CHARTER TOWNSHIP OF VAN BUREN PLANNING COMMISSION AGENDA Wednesday, May 10th, 2023 – 5:30 PM Van Buren Township Hall 46425 Tyler Road

ITEM # 1 Case 23-020- Van Buren Charter Township Accessory Gasoline Filling Station

Review: Site Plan Review #2
Plans Dated: April 24, 2023
Review Date: May 4, 2023

E101P

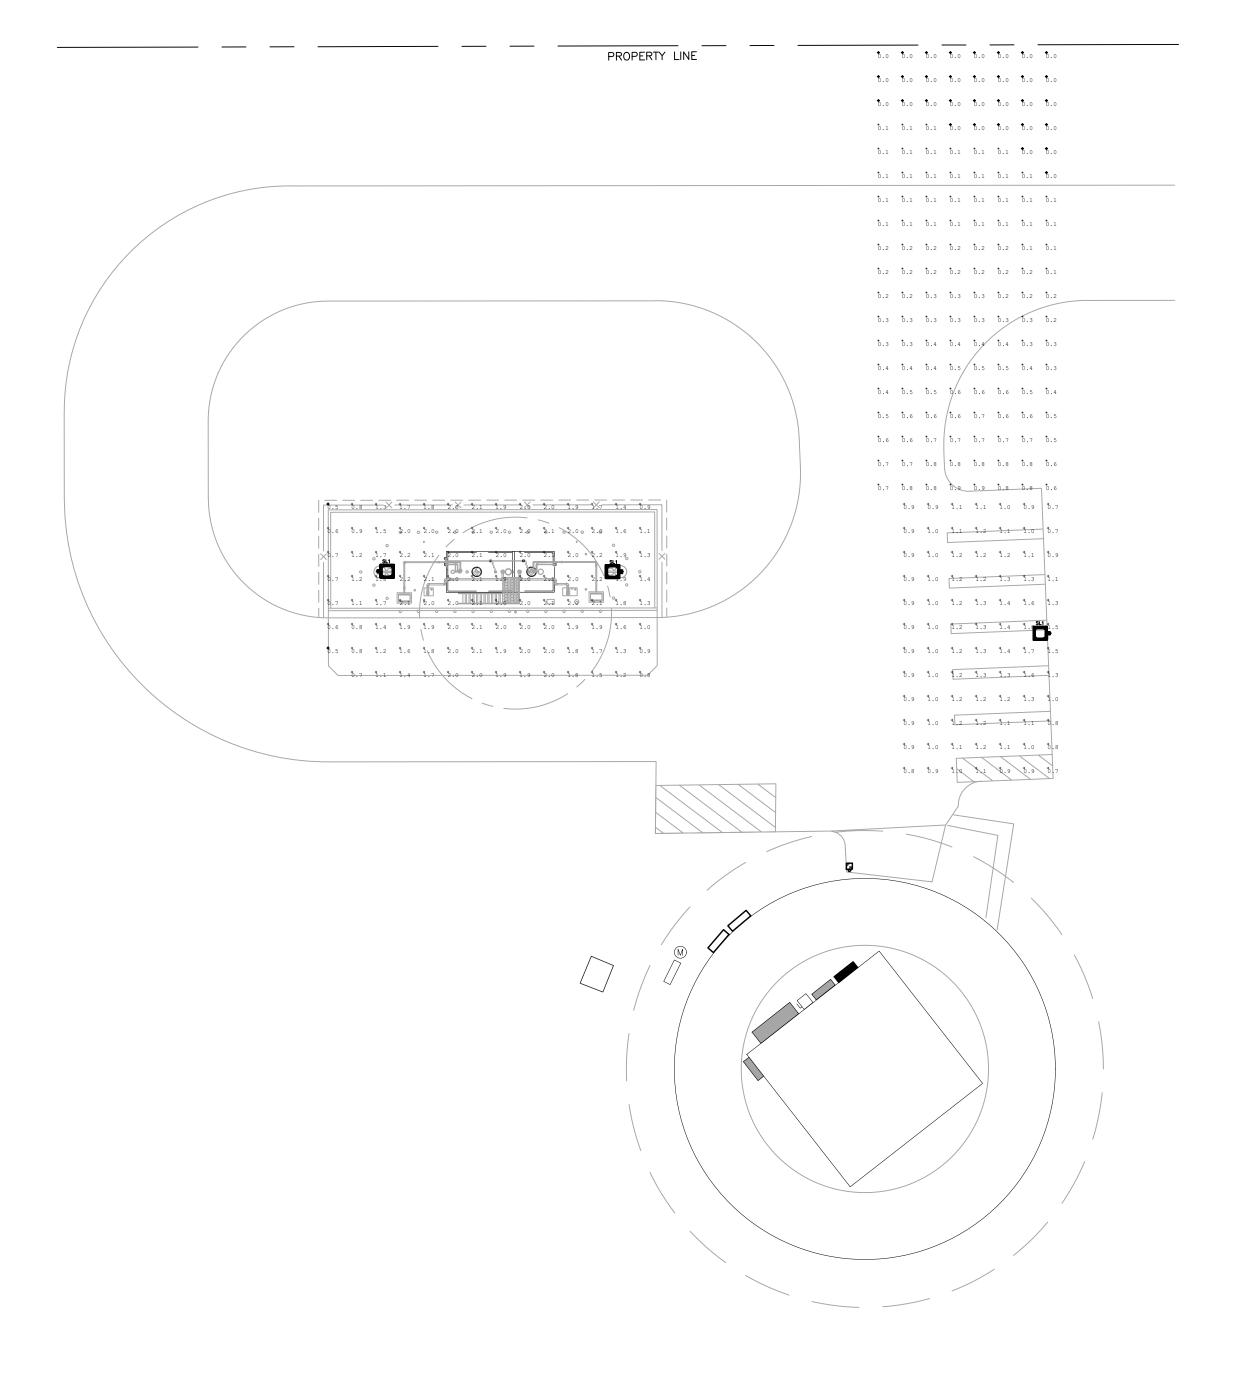
- 7. The photometric plan will need to be amended to show the lighting levels from both lighted areas to the property line and that the lighting shall not exceed 0.5 foot candles per the Zoning Ordinance.

L101 LANDSCAPE PLAN

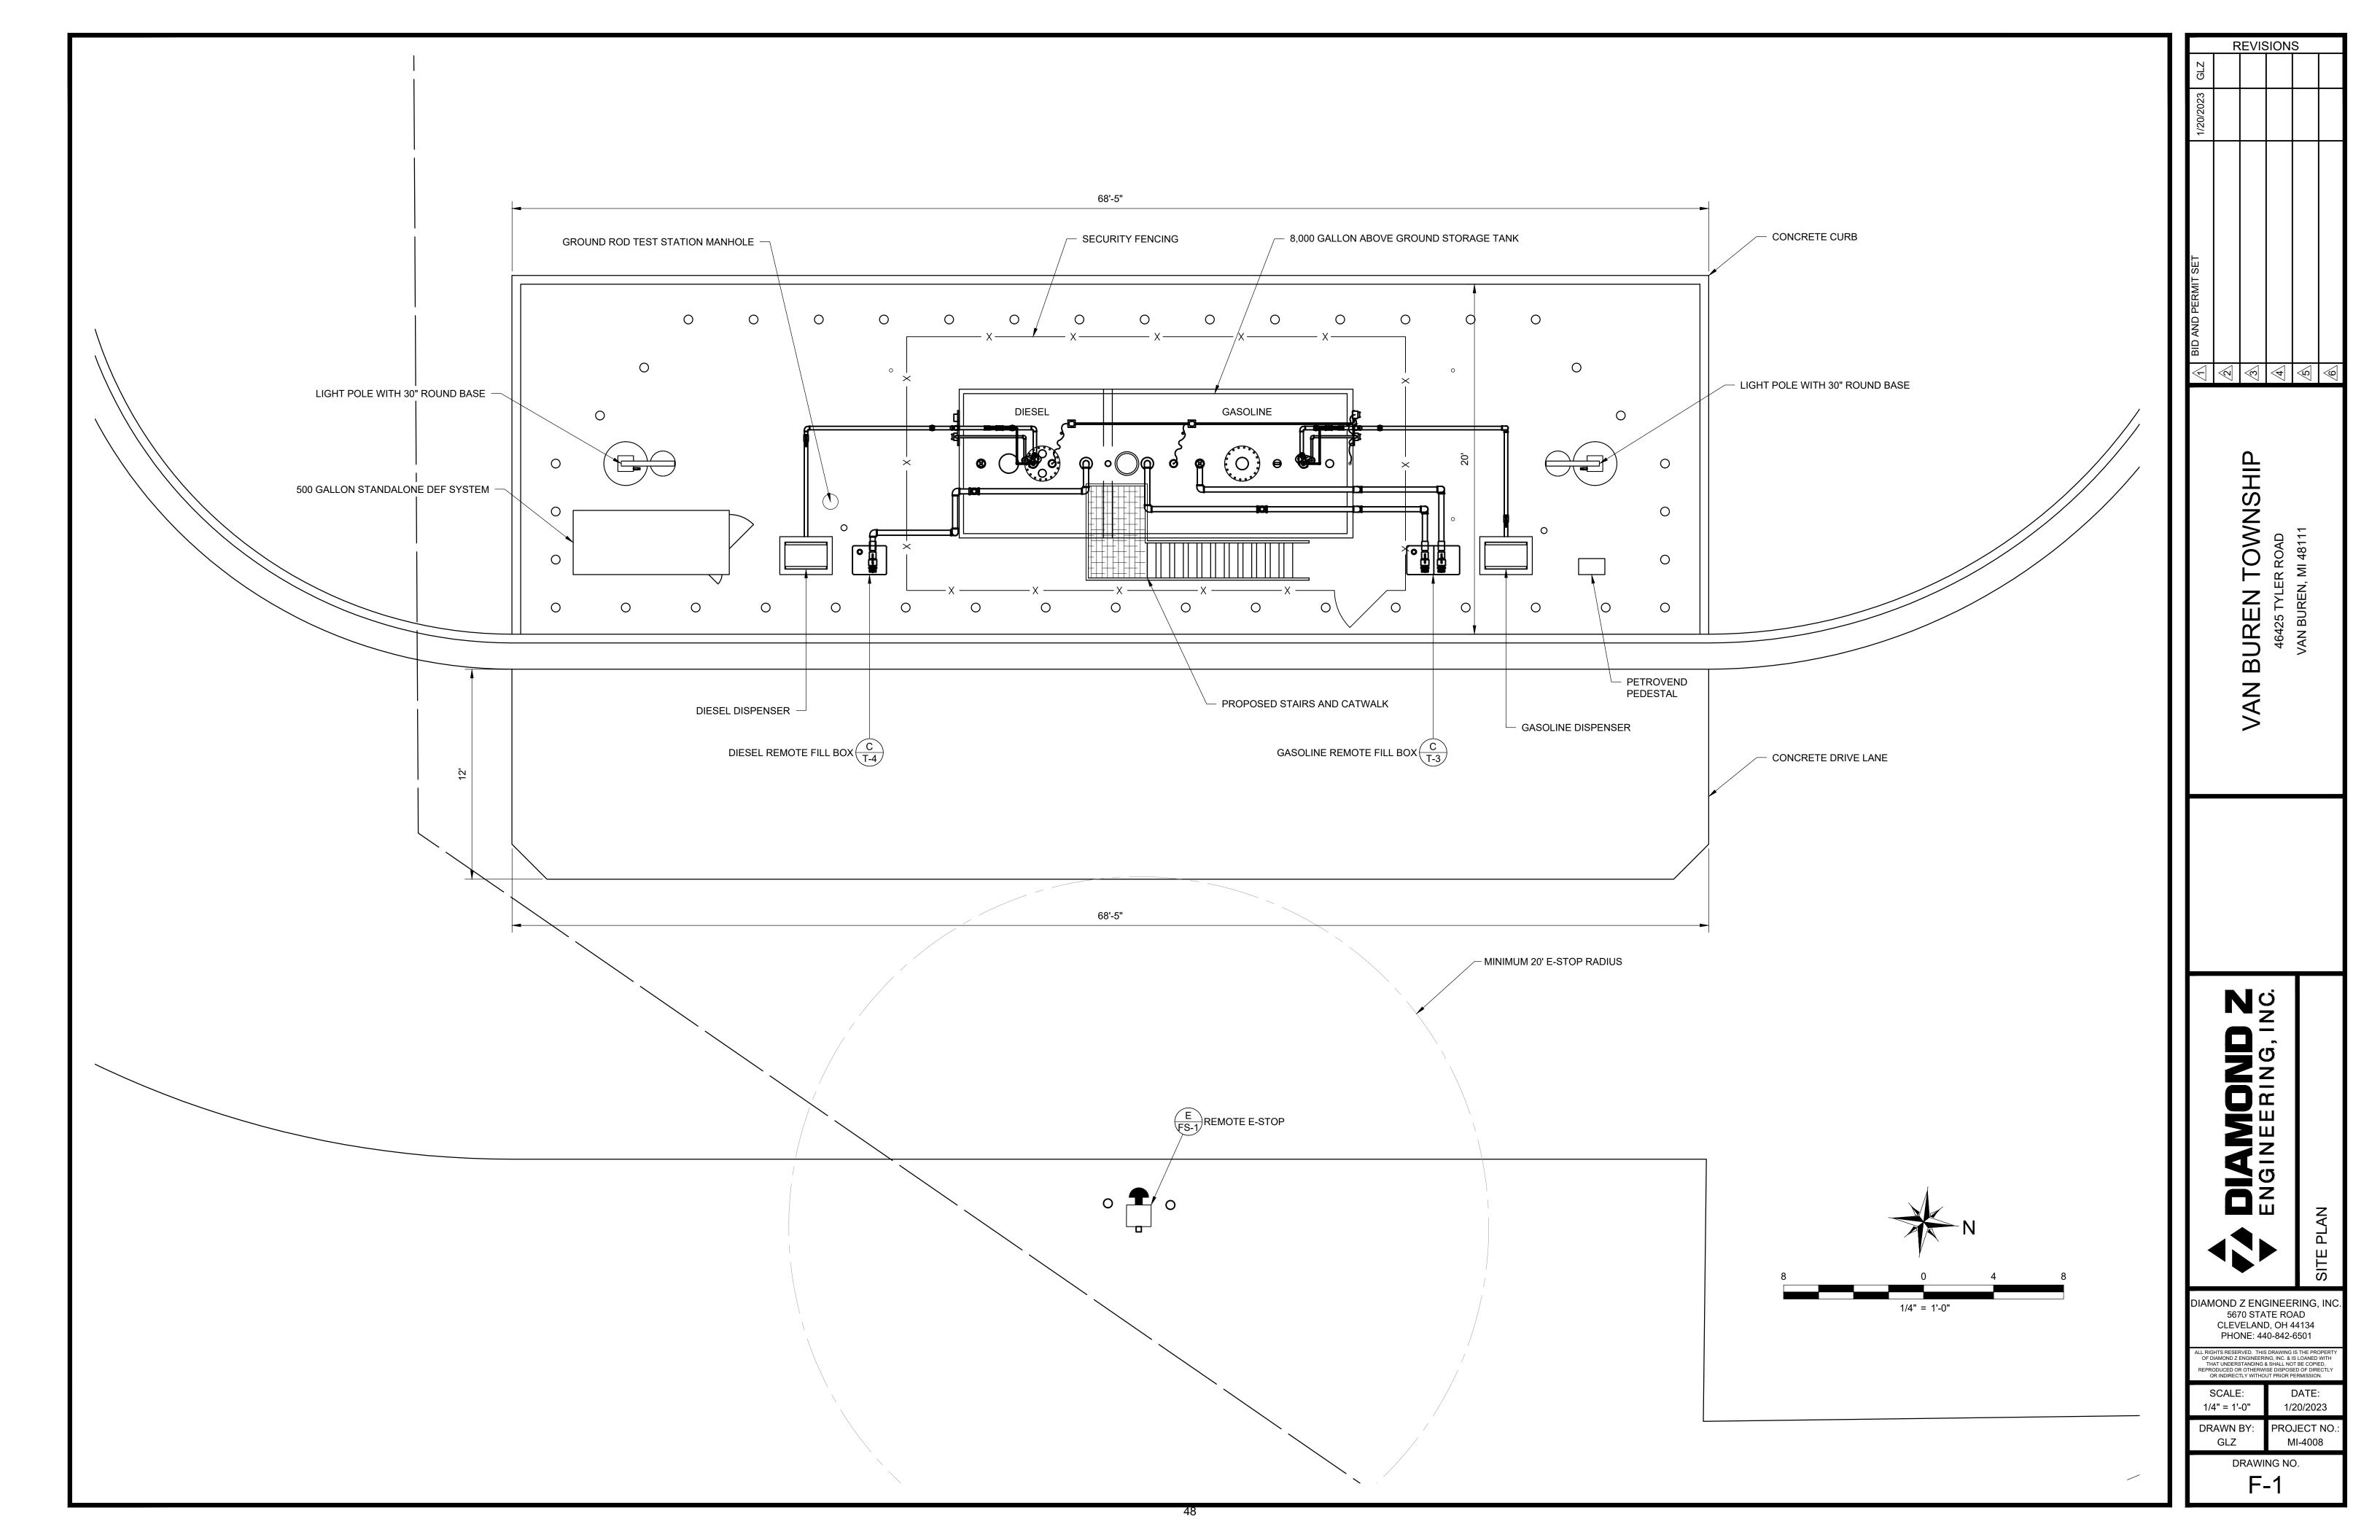
The plant schedule lists the size of the evergreen white pine trees as a 3" caliper incorrectly. This should list the height of the evergreen tree (8' minimum). It will also need to be noted that the evergreen shrubs will be a minimum 30" in height at the time of planting.

- 5. The Landscape plan be amended to revise the size of the white pine trees from a 3" caliper tree to a ten (10) foot tall tree.
- 6. The Planning Commission authorizes a waiver from the installation of an irrigation system and acknowledges that the Township has a contractor which provides landscape maintenance for our properties which would include watering.
